Access Compliance Report to accompany a

Development Application

Development Address: 2 Cambridge Street, Epping

Client: ZHINAR Architects

Pre-adaptation shown above.

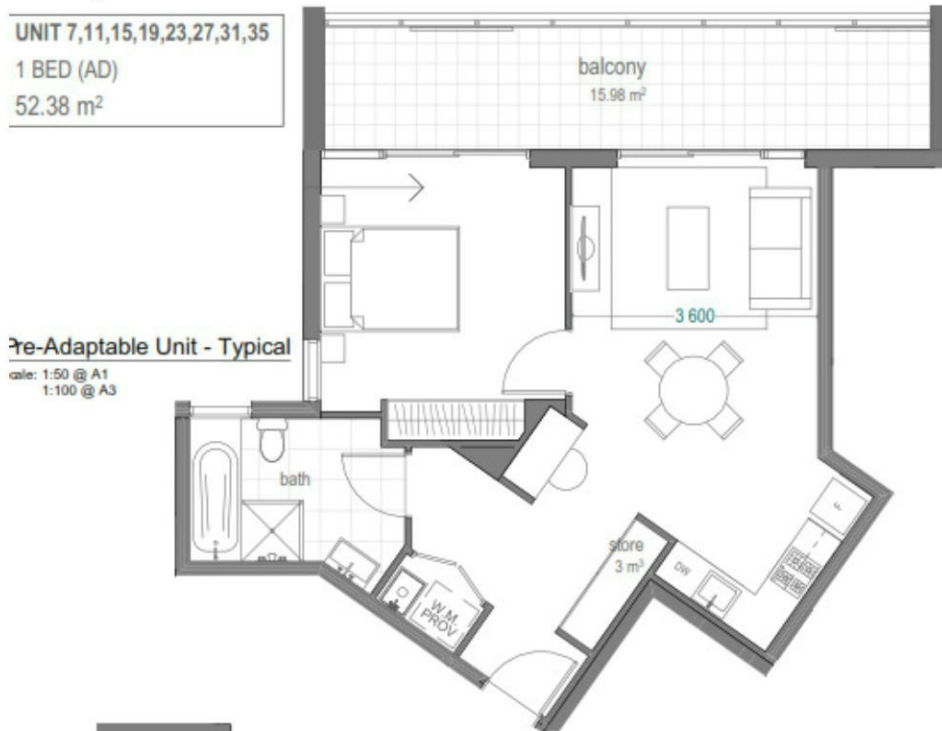
The units designated as adaptable are units **8, 7, 11, 15, 19, 23, 27, 31, and 35**

At DA stage there is insufficient information to certify compliance with the Standard, however, in accordance with the table below, the nominated units can comply with the spatial requirements of AS4299 for Adaptable Housing.

3 Pre-Adaptable Unit 8
Scale: 1:50 @ A1
1:100 @ A3

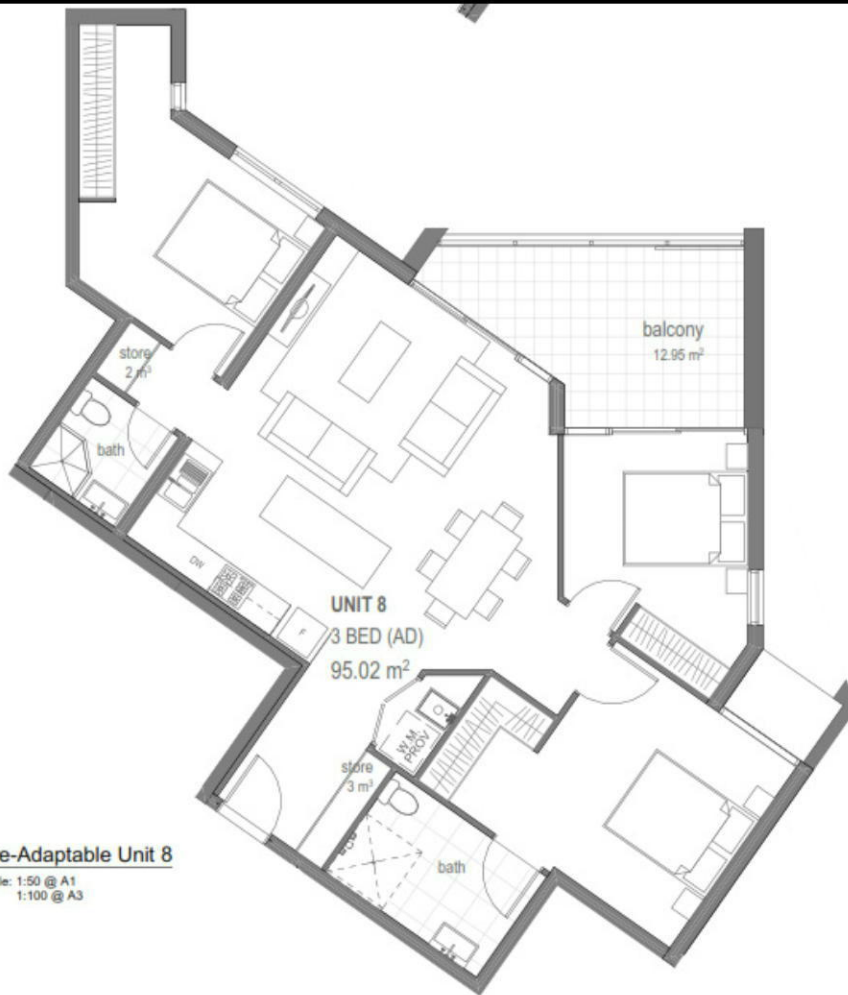
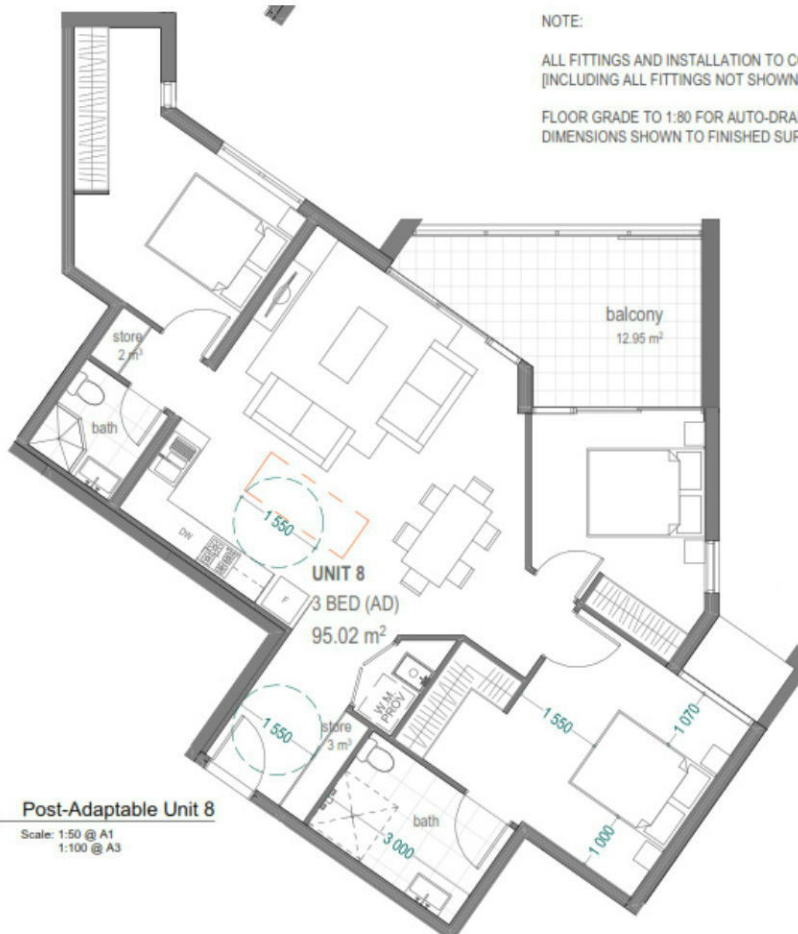
By incorporating the essential requirements listed below in the Specifications, the nominated Adaptable units can achieve full compliance with Adaptable House Class C

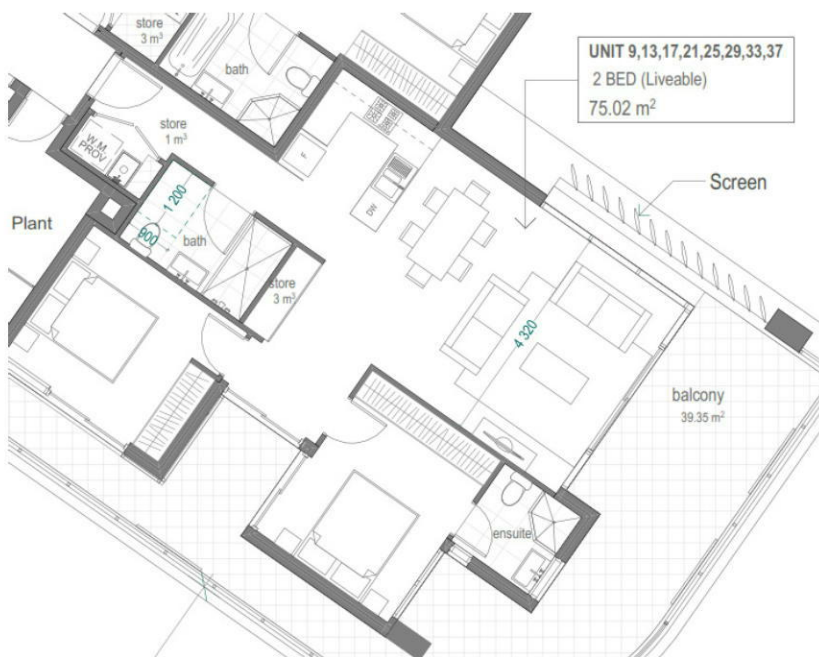
Units 9, 13, 17, 21, 25, 29, 33, 37, 40, 44, 48, 52, 56, 60, 64, 68, 72 are capable of providing compliance with the features of Silver level of Livable Housing Guidelines as noted in the table below.
